AS-BUILT BASELINE MONITORING REPORT

WYANT LANDS MITIGATION SITE

RE: Wyant Lands Mitigation Site As-Built/MY0
Lincoln County, NC
Response to NCIRT Review Comments
USACE Action ID No: SAW-2017-02609
NCDMS Project No: 100067

Subject: Draft As-Built Baseline Monitoring Report (MY0) and Record Drawings & Mitigation Plan Addendum for the Wyant Lands Mitigation Site
Catawba River Basin – CU# 03050102 – Lincoln County
DMS Project ID No. 100067
Contract # 7244

Wyant Creek
 Stream Plan and Profile

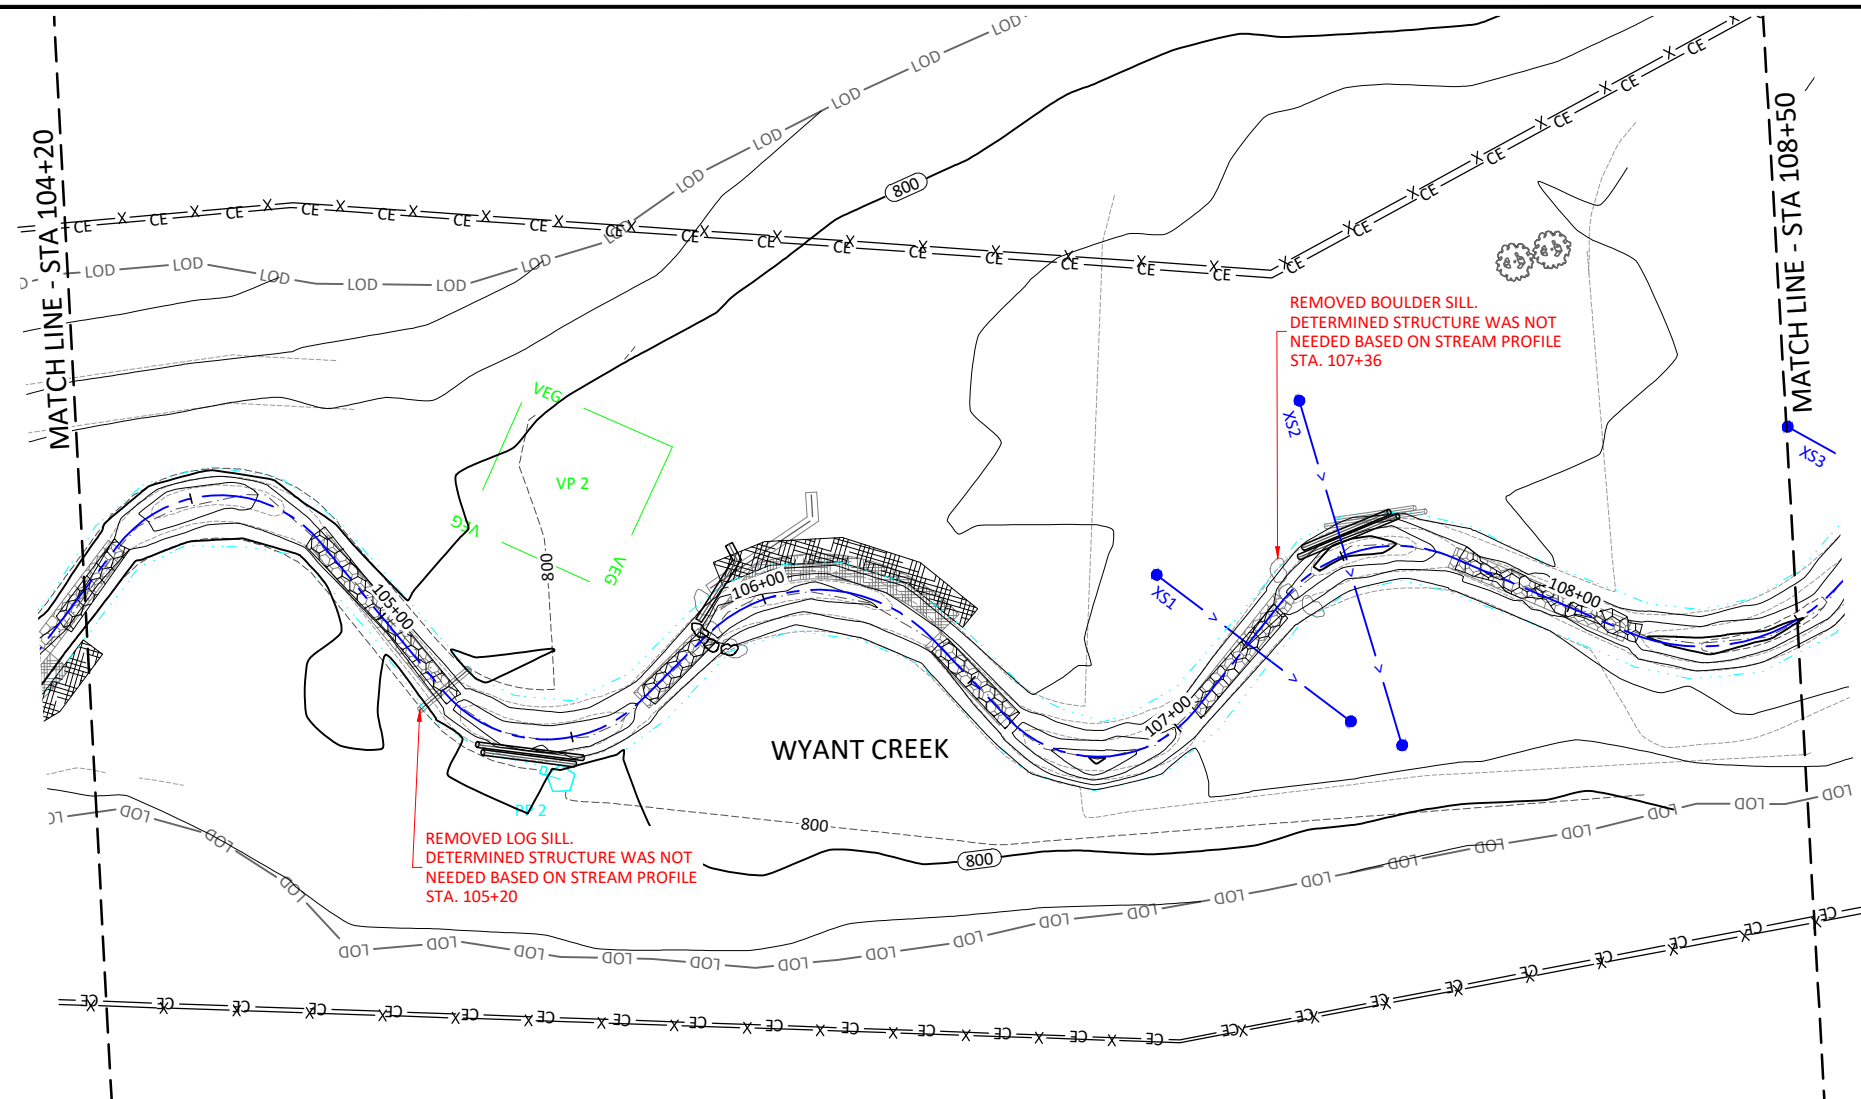
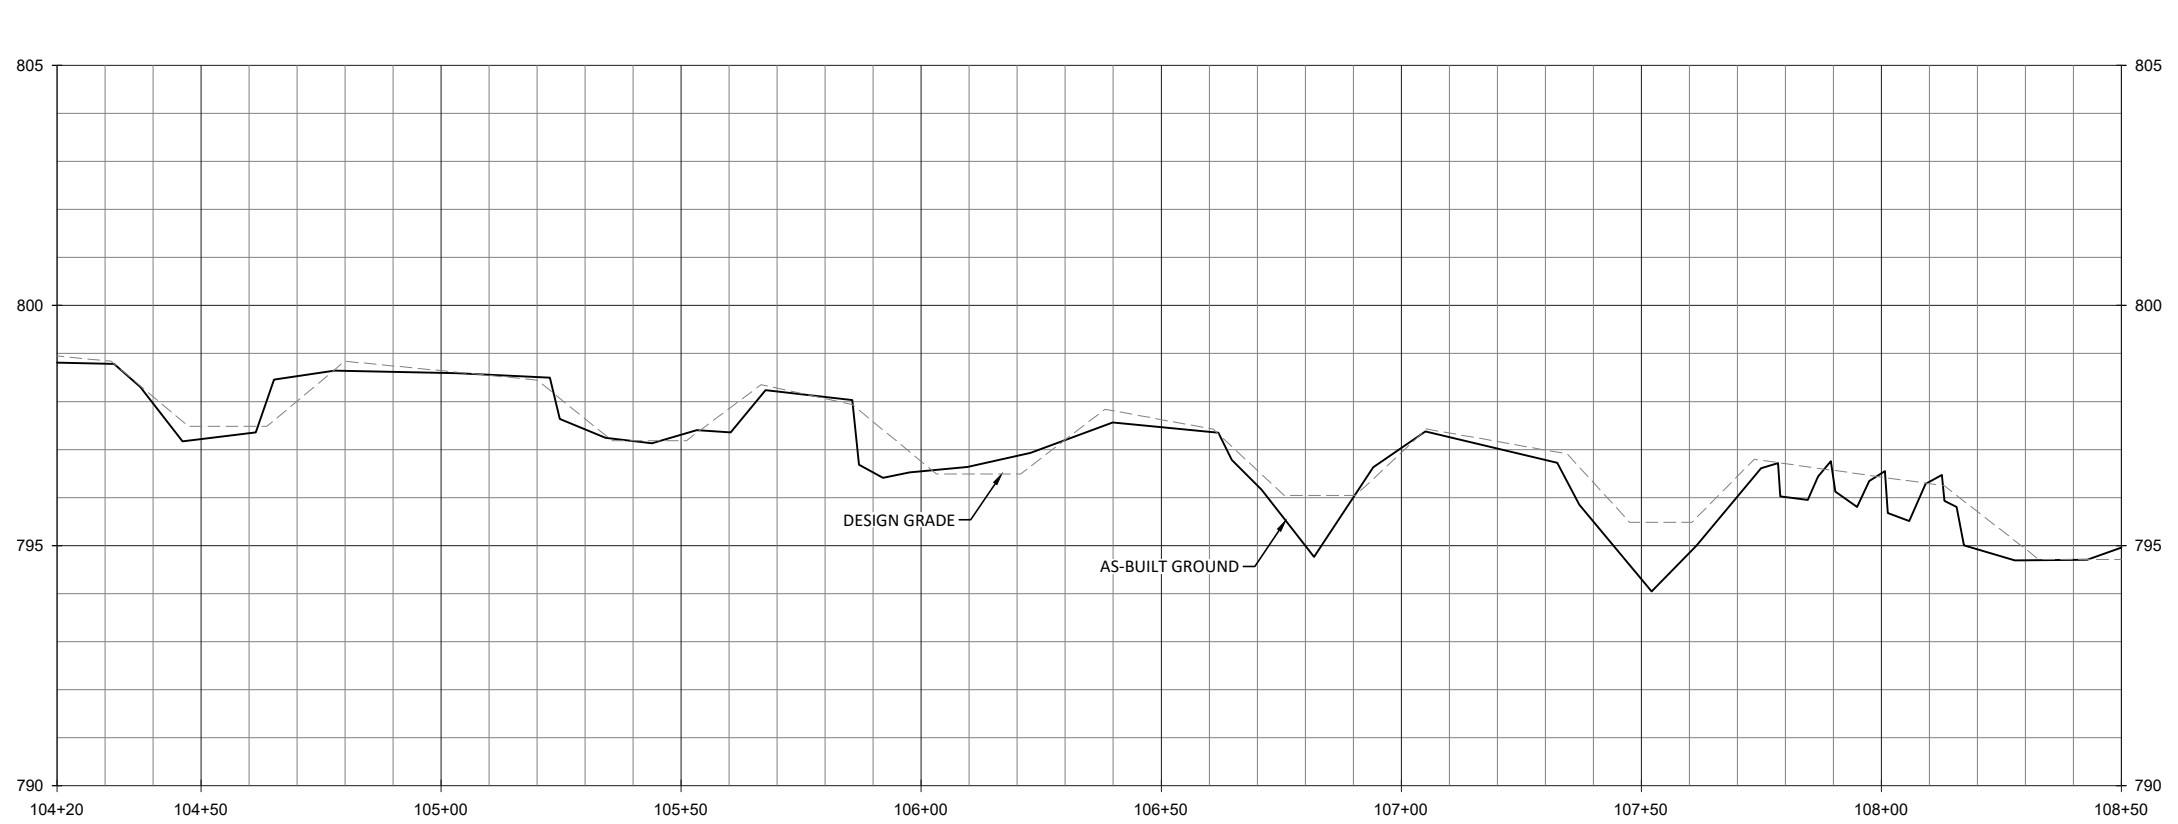
- Sheet 1.1 notes; “Pools have filled with offsite sediment. Expect sediment to clear as channel stabilizes.” Please also discuss this in the report text.

- **Sheet 1.1 notes:** *"Pools have filled with offsite sediment. Expect sediment to clear as channel stabilizes." Please also discuss this in the report text.*
 - Text was added to Section 5.1 of the report discussing the sediment within the upstream pools of Wyant Creek Reach 1.
